POINT BEACH NUCLEAR PLANT, UNIT NO. 1

AMENDMENT TO FACILITY OPERATING LICENSE

Amendment No. 53
License No. DPR-24

AMENDMENT NO. 53 TO FACILITY OPERATING LICENSE NO. DPR-24

Figure 15.3.1-1/PBNP Unit No. 1
Heatup Limitations Applicable to
14 Effective Full Power Years
(Approximately January 1990)
Instrument Error Included

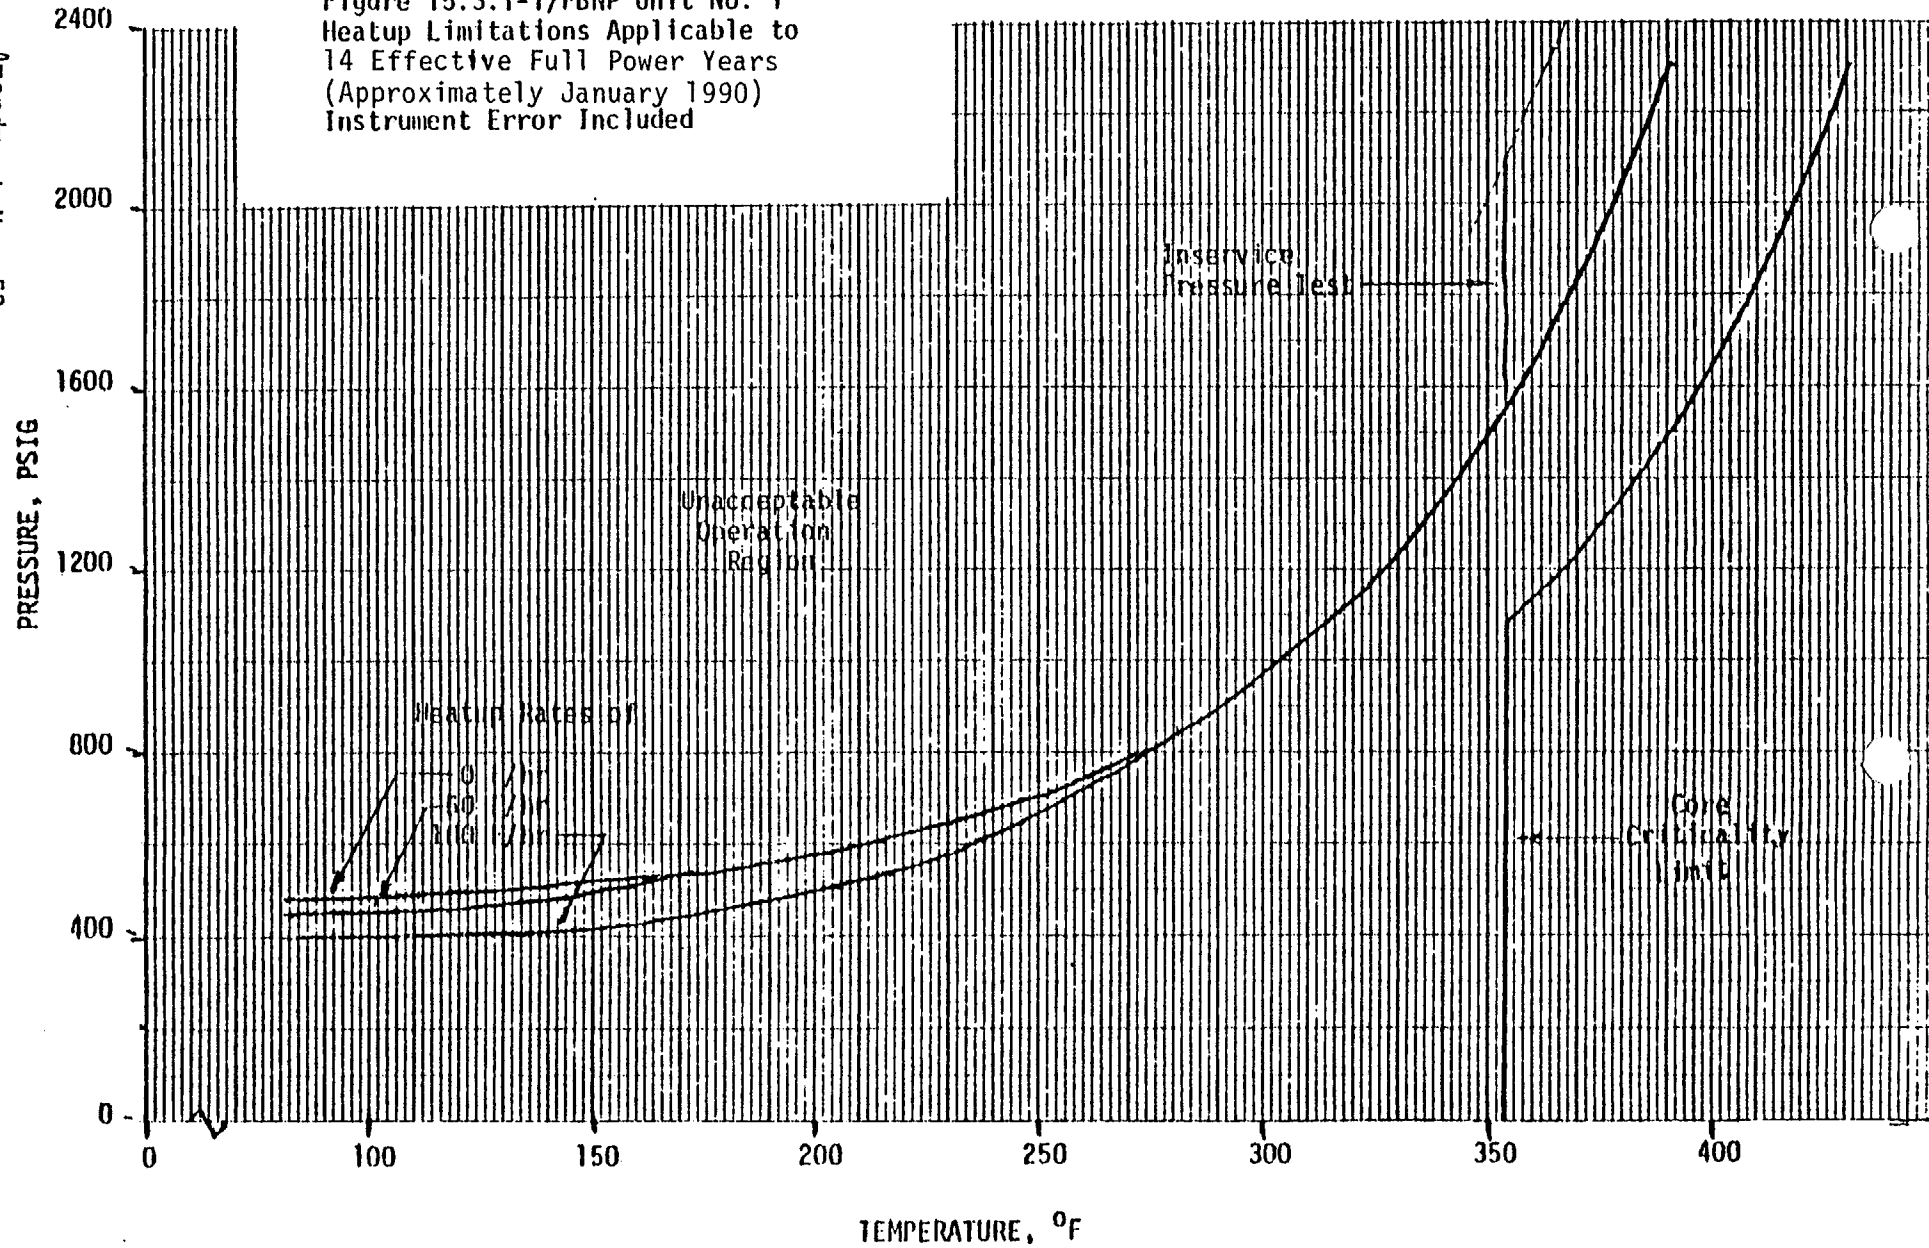
These amendments update the reactor coolant system temperature and pressure operating curves for Unit 1 and make minor related administrative changes to the Unit 2 Technical Specifications.

Subsequent telephone conversations with members of your staff have indicated your verbal authorization of a revised operating interval of 14 EFPY for the Unit 1 operating curves. The NRC staff has previously approved this operating interval in our SER dated July 10, 1981 which constitutes our Safety Evaluation on this matter.
